STOCK & ASSOCIATES
Consulting Engineers, Inc.

Re: PZ 09 and 10-2016 40 West Luxury Living (KU Development, LLC.)
Responses to Public Hearing Comments Letter September 30, 2016
(Stock Project No. 215-5541)

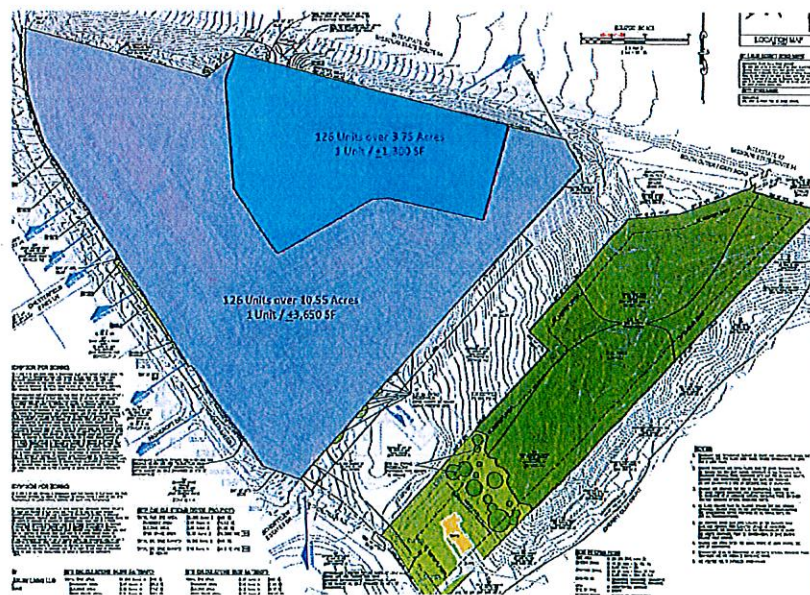
Comment 2. Address the appropriateness of the density you are requesting for this project.

Considerable changes were made to this plan as compared to the previous plan. These items are expanded further in the following sections.

- 1) An entire residential building was eliminated.
- 2) Open space was further increased.
- 3) The density of the development was shifted to the two buildings along the interstate and conversely reduced along the bordering Single-Family residence.
- 4) The number of units and parking spaces further decreased.
- 5) The open space around 1410 Schoettler Road (Single Residence) was significantly increased.
- 6) The addition of a 5.25 acre land donation to the city.

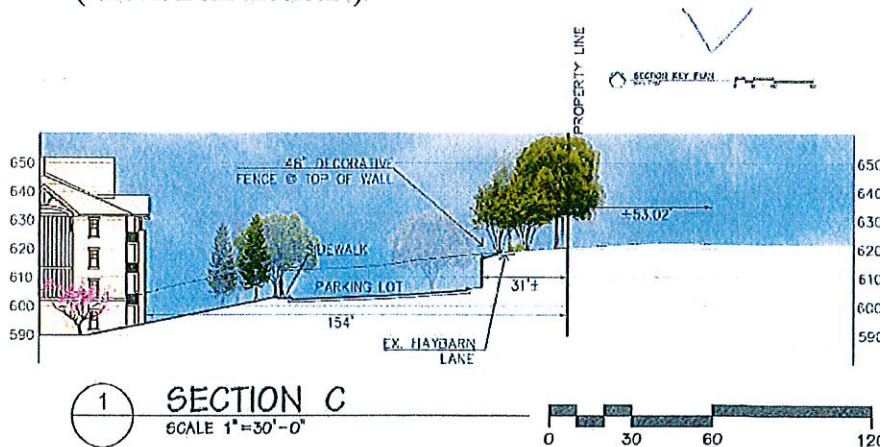
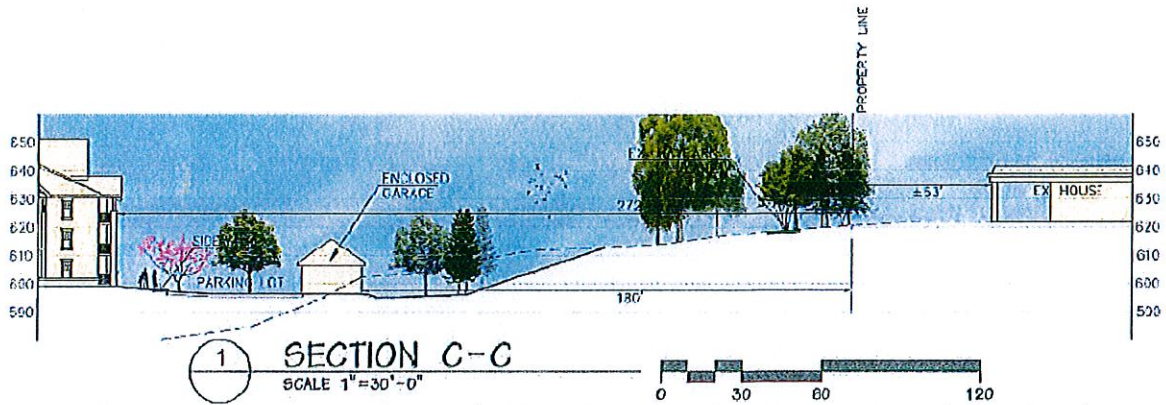
Comment 6. Provide information regarding the impact of this proposal on property not included in this petition but bordering it on both sides (1410 Schoettler Road).

In addition, we have made significant modifications to the property line between 1410 Schoettler and the residential garden building. This includes the elimination of an entire building and associated parking and the elimination of the retaining wall abutting the property. This below modification is best illustrated on the images below that compare the prior submission to the revised one.

This image represents the old plan.

- 1) The old plan showed +/-31ft from the property line to the retaining wall/parking lot.
- 2) The old plan contained a 12ft retaining wall.
- 3) The old plan showed +/-154ft from the property line to the edge of the garden unit (+/207ft from the house).

This image represents the new plan.

- 1) This plan shows +/-180ft from the property line to the edge of the enclosed garage. Increase of +/-150ft.
- 2) No retaining wall.
- 3) This plan shows +/-270ft from the property line to the edge of the garden unit (+/-323ft from the house). Increase of +/-116ft.
